For: Current Inrush Limiting Circuit

DECLARATION UNDER 37 CFR 1.131

A794/A758 Intrush Control Review

From: Randy Bullock
 To: Scott Lewis
 Cc: Mike Franzen, Denny Coon, Jim DelSignore, Bob McCarney, Barry Shaw, Mike Gera, Rick George, Bob Delaney
 Date:
 Subject: Design Review for A758/A794 USB/RS232 Serial Option PCBA, artwork number M257/M282.

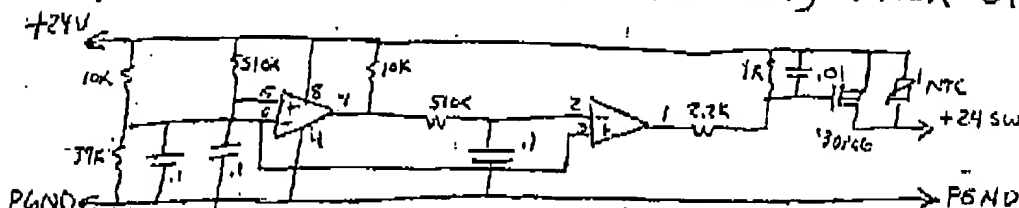
1. Does A794 need inrush control at all; with only 1000 μ F electrolytic I doubt it.
 \Rightarrow Remove inrush circuit from all A794 option boards if inrush is below 10A (Measure max. inrush into 1000 μ F)
2. Current inrush ckt. works fine as long as 1st charge cycle is very close to full before FET turns on, ckt. has many parts, could be simpler.
Concern: (a) Secondary current pulse can be large depending on lots of variables...
b) To take charge-up time is ~~inversely proportional to~~ $\frac{1}{I_{inrush}}$
3. Keep present ckt. but remove the NPN, switch UI pins 243

4. Do we need a dual computer for this delay function? No.

With this circuit, a softer turn-on of the FET allows shorter delay.

This works fine, exactly as previous circuit but less 1 50K-23 NPN and 1 resistor

A794/A758 Inrush Control Review (continued from p.34)

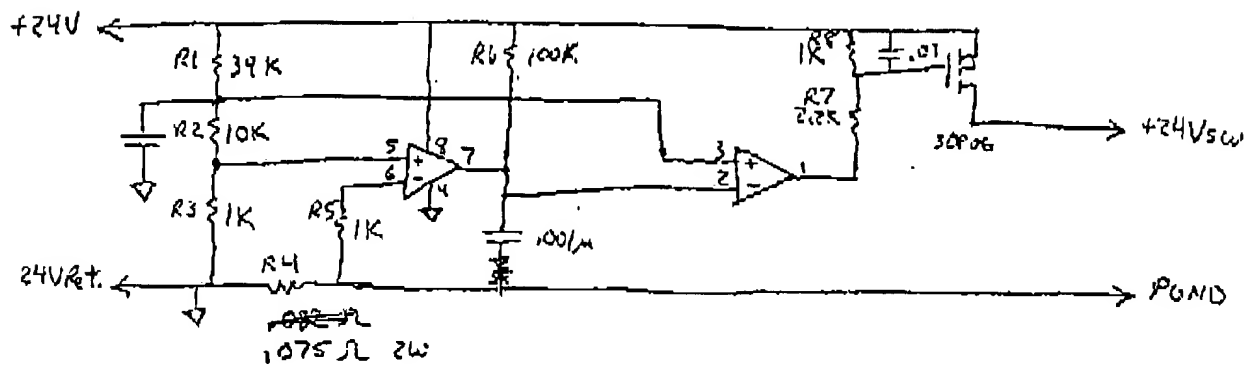
- 5.8 Alternate approach - get rid of NTC thermistor, keep comparator, but re-configure as a chopper current-limiting device.
- Whenever current draw exceeds setpoint, FET is turned off for a short time before re-enabled. This would be set well above the DC supply rating so that normal print operation does not trigger the circuit. During startup (1st supply connection or power-on) and fault conditions the switcher would kick in.
 - During normal oper., FET is ON continuously.

Recommend change 1075Ω to 1082Ω

- If concern re. early chip during print, raise set-point as long as terminal supply can handle higher I_{pk} .

$$\Rightarrow I_p = 6.4A \quad I_{rms} = 2.7A \quad T_{delay} = 66ms$$
